Technical Service Bulletin

Subject: LIGHT RESISTANCE AND/OR UNUSUAL NOISE WHEN TURNING STEERING WHEEL LEFT OR RIGHT	Bulletin No.: 06-001/20
	Last Issued: 02/05/2020

This bulletin supersedes the previously issued bulletin(s) listed below. The changes are noted in Red text.

[R] Parts (*1) (*2) Location:

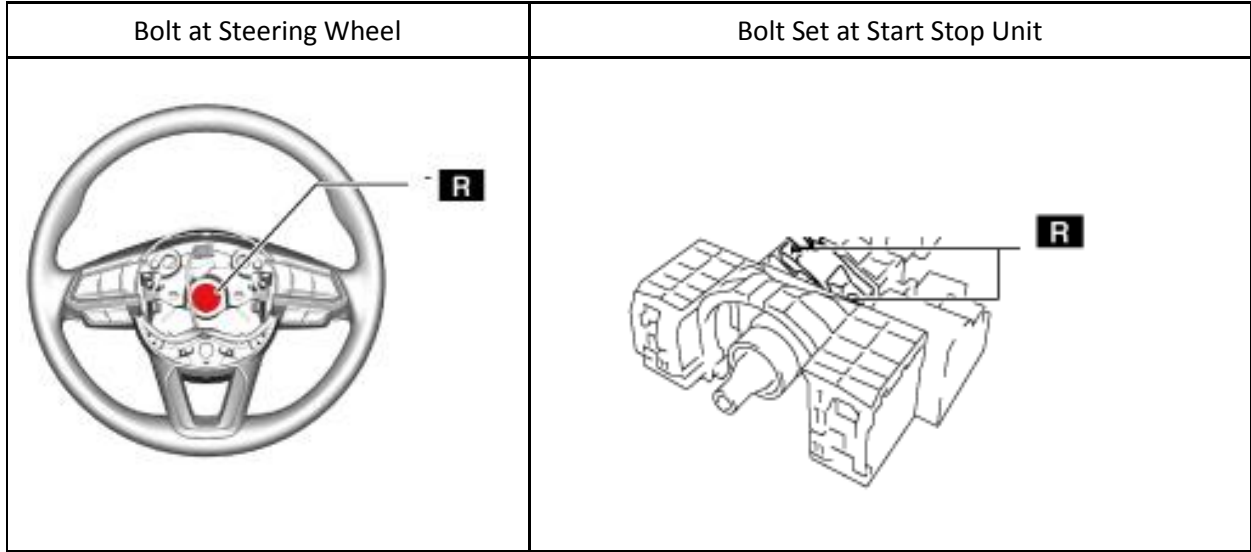
Parts Number	Description	Qty.	Notes
DA7H-32-100N	Shaft, Steering	1	2016-2017 Mazda2
DG7L-32-100F	Shaft, Steering	1	2018-2019 Mazda2
DHM1-32-100A	Shaft, SteeringShaft, SteeringShaft, SteeringShaft, Steering	1	2020 Mazda2
DB4G-32-100K	Shaft, Steering	1	2016-2017 CX-3
DH1E-32-100D	Shaft, Steering	1	2018-2019 CX-3
DM6F-32-100C	Shaft, SteeringShaft, SteeringShaft, Steering	1	2020 CX-3
B455-32-099B	Shaft, Bolt	1	[R]
D10J-32-099	Shaft, Bolt	1	[R]
9YA0-11-003A	Bolt	1	[R] (*1)
KA01-66-154	Bolt, Set	2	[R] (*2)

[R] = Replace
